Access Compliance Report Public Rights-of-Way (Pedestrian Signals)

Intersection ID: N/A	Main Street:	Cross Street: N/A	Location: N/A
ADA ID: 4A1DD12A35C2	Signal Type: One Push Button-APS	Overall Compliance: No	Severity Score: BTN 1: N/A BTN 2: N/A No BTN: N/A
Codes/Mitigation Info/Possible Solution		Field Measurements/Component Compliance

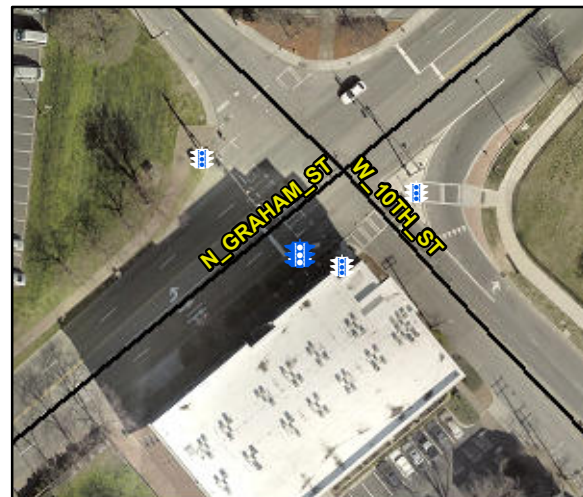
Surveyor Notes: TEXT HT 3/8

PROW/ADA: R410.6, TMUTCD 4e.08, R404.2, R404.3, R406.2, R209.1, MUTCD 4e.10

Yes B 1 Clear Xing Direction?	ClearlyMarked	N/A B 2 Clear Xing Direction?	N/A
B 1 Crossing Direction	To NW	B 2 Crossing Direction	N/A
Yes B 1 DistanceTo XWalk (in)	40.0	N/A B 2 DistanceTo XWalk (in)	N/A
No B 1 DistanceTo Curb (in)	103.0	N/A B 2 DistanceTo Curb (in)	N/A
Yes B 1 Diameter (in)	2.0	N/A B 2 Diameter (in)	N/A

Possible Solutions: Replace Signal Push Button With APS Button on New Post. Remove & Replace Sign.
